ENVIRONMENTAL ASSESSMENT OF THE PROPOSED CRRRC

Response to Wallach - Critical Review of Geoscientific Component of TMES EA Final Version, February 2, 2015

Report Number: 12-1125-0045/13000

FIGURE 3-5

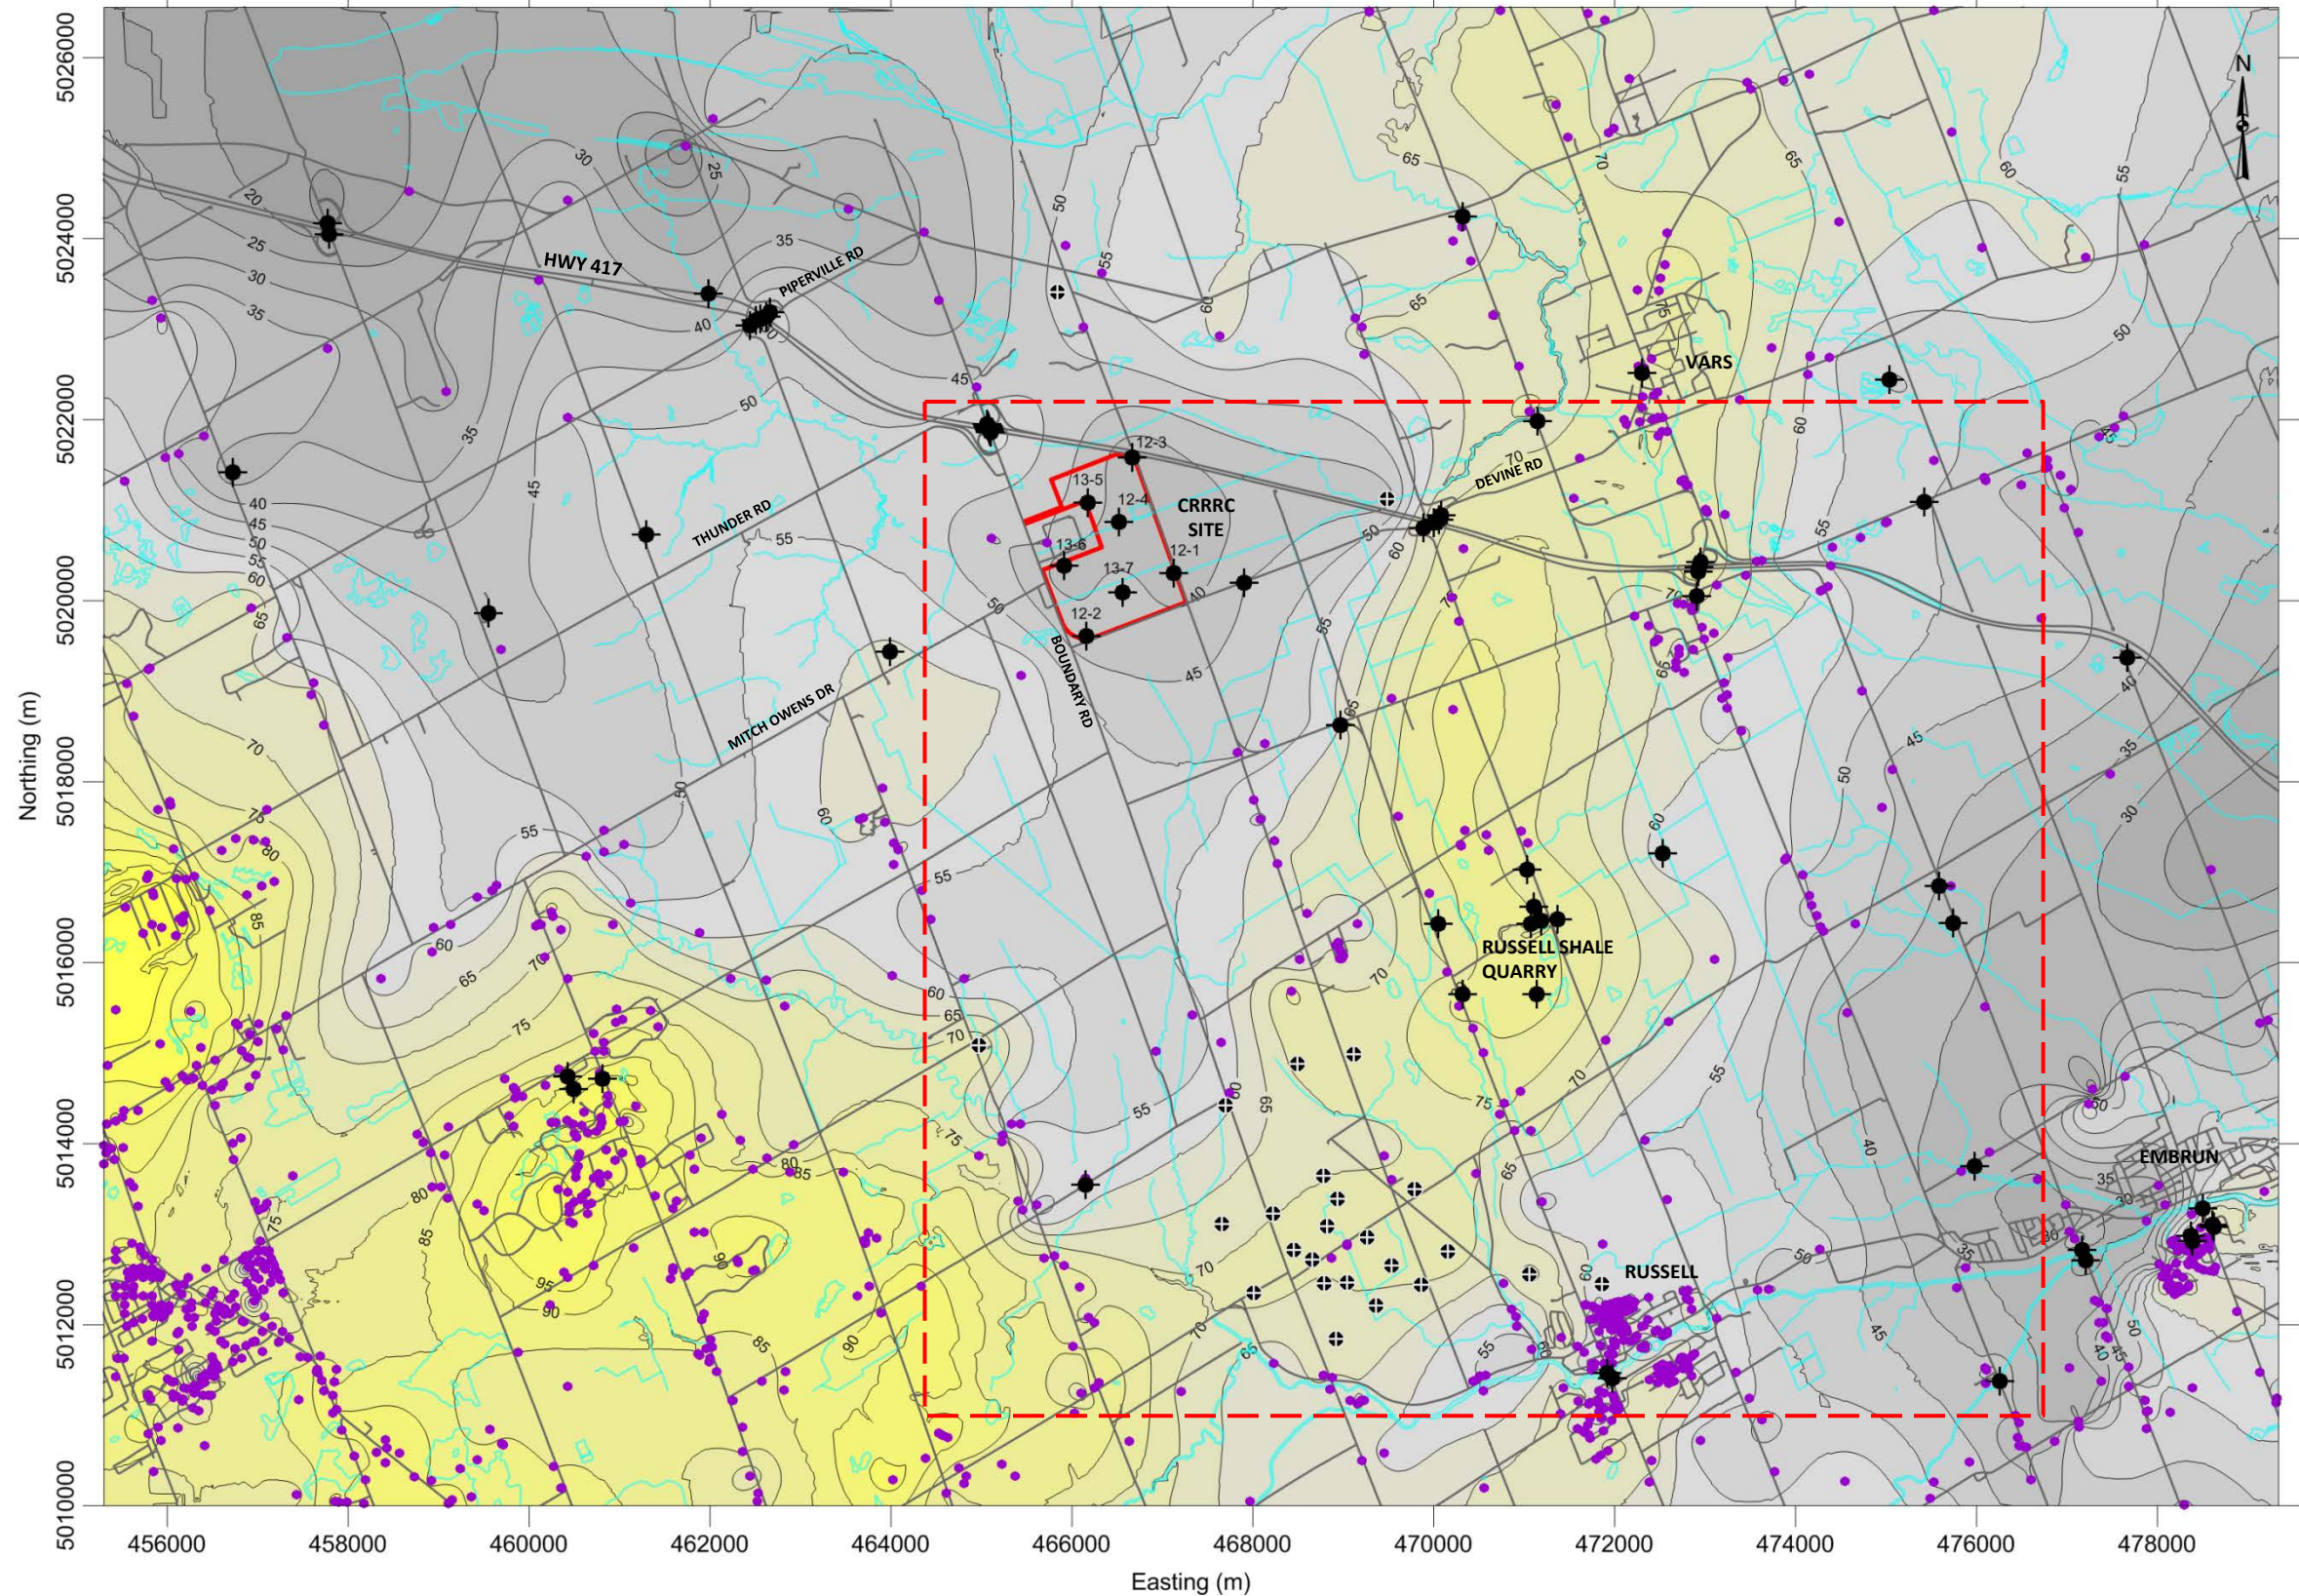
For the areas north of the Gloucester and Russell-Rigaud fault zones where the Queenston Formation is not present, the top surface of the bedrock (Figure 3-5) should be coincident with the eroded surface of the Carlsbad Formation (Figure 12), not a structural plain. The maps in the Wallach paper and in the EA document are generally in agreement in the areas east of “Cholowski Hill”. Southeast of “Cholowski Hill” and northeast of Russell, Ontario, however, the Wallach (2014) Carlsbad Formation surface elevation is approximately 10 m lower than the bedrock surface elevation presented in the Volume III Report, likely reflecting water well discrepancies as previously discussed.

Our interpretation of the bedrock surface topography beneath the local study area is shown on Figure 3-5. The interpretation was made from a combined dataset of site-specific investigation boreholes for the CRRRC project and other investigations, MOECC water well information (1,274 data points); and 26 exploration gas wells. The Wallach (2014) study area is inset in Figure 3-5. We found that the bedrock surface has a vertical relief of approximately 90 metres within the local study area. In the southwestern corner of the area where the Oxford Formation dolostone bedrock is at or near surface, bedrock occurs at elevations of approximately 75 mASL to 105 mASL. In the northwestern corner of the local study area where the ground surface is between approximately 65 mASL to 75 mASL, the Carlsbad Formation shale bedrock elevation occurs at approximately 15 mASL to 25 mASL.

Wallach (2014) does not provide bedrock surface contours; rather he presents structure contours for geological formations below the base of the Queenston Formation. Thus, in areas underlain by Queenston Formation as the uppermost bedrock unit (Figure 3-6), it is not possible to compare the top of bedrock map shown on Figure 3-5 to the Wallach (2014) geological interpretation. Where the Queenston Formation is present, however, the top elevation of the Carlsbad Formation (Figure 12) should be below the top-of-bedrock elevation (Figure 3-5). A comparison of the Wallach (2014) Figure 12 and Golder Associates Figure 3-5 indicates major discrepancies. For example, in the area north of the Gloucester Fault Zone and west of Boundary Road (adjacent to the Boundary Road Site), Wallach (2014) interprets the top elevation of the Carlsbad Formation to be significantly higher (60 to 70 mASL) than the top elevation of the bedrock surface in that area (approximately 50 to 55 mASL), and associates this with the presence of a fault. As described in Section 2.1.2.1, this fault was inferred by Dr. Wallach using incorrect water well records from Marionville located some 16 kilometres from the Site.

FIGURE 3-7

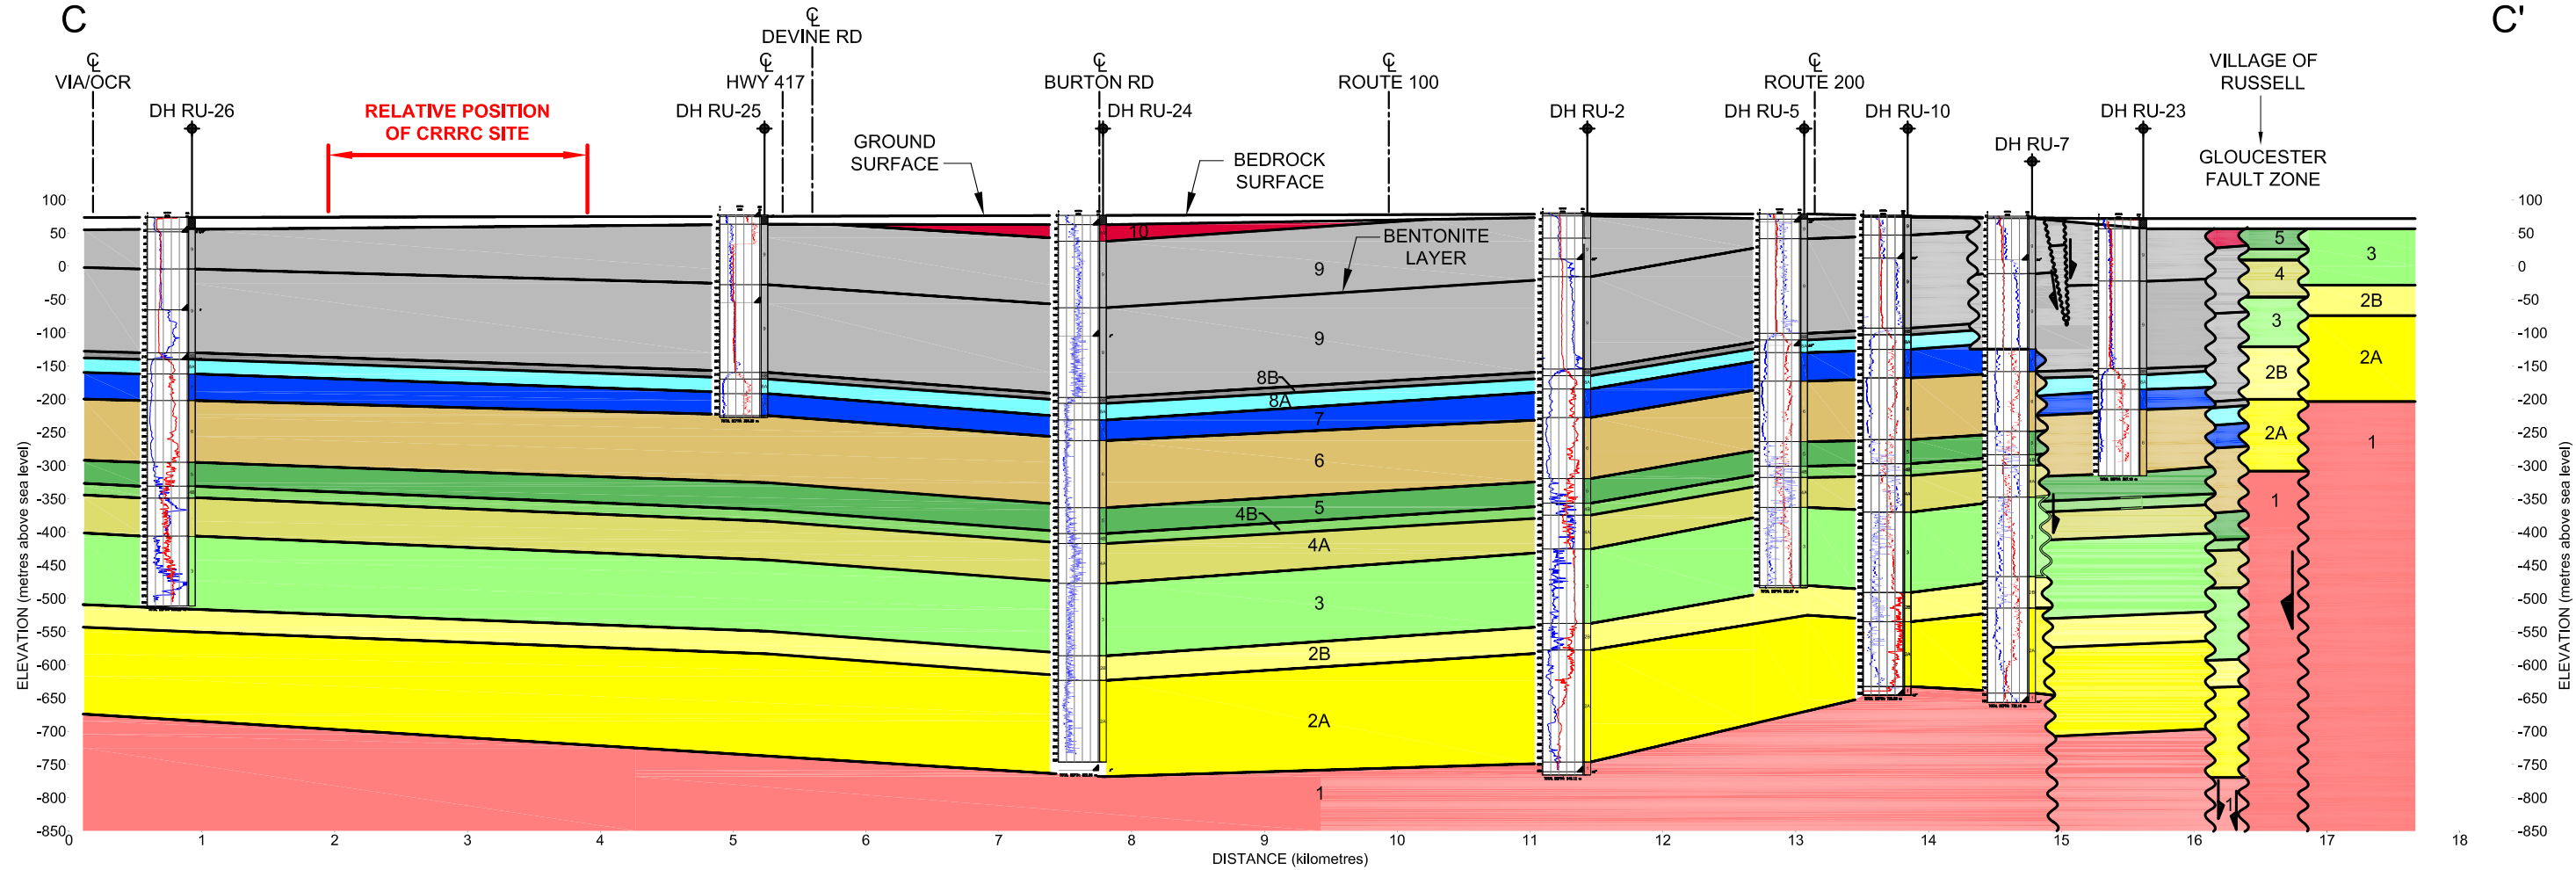
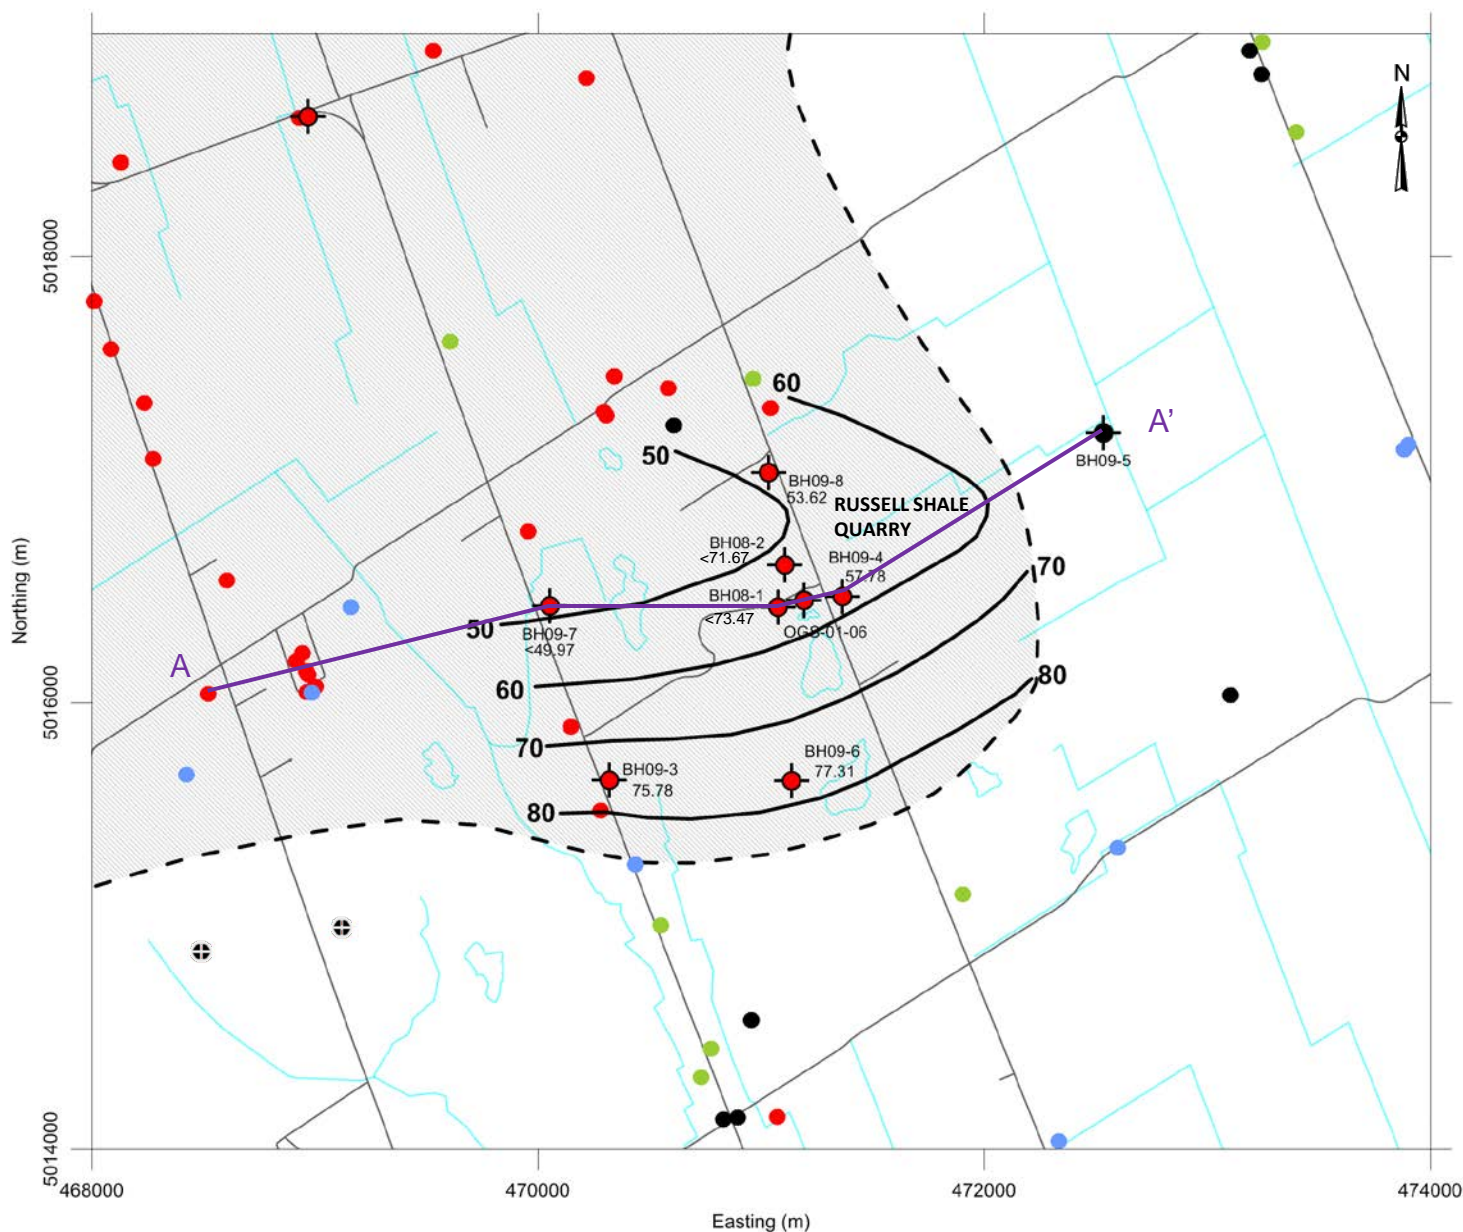
The major fault structure within the Local Study area is the Gloucester and Russell-Rigaud Fault system. As shown on Figure 3-7, the Gloucester Fault comprises a series of fault planes within a zone approximately 0.75 kilometres wide beneath the community of Russell. The Gloucester and Russell-Rigaud Fault system is a well-documented, normal-slip fault.
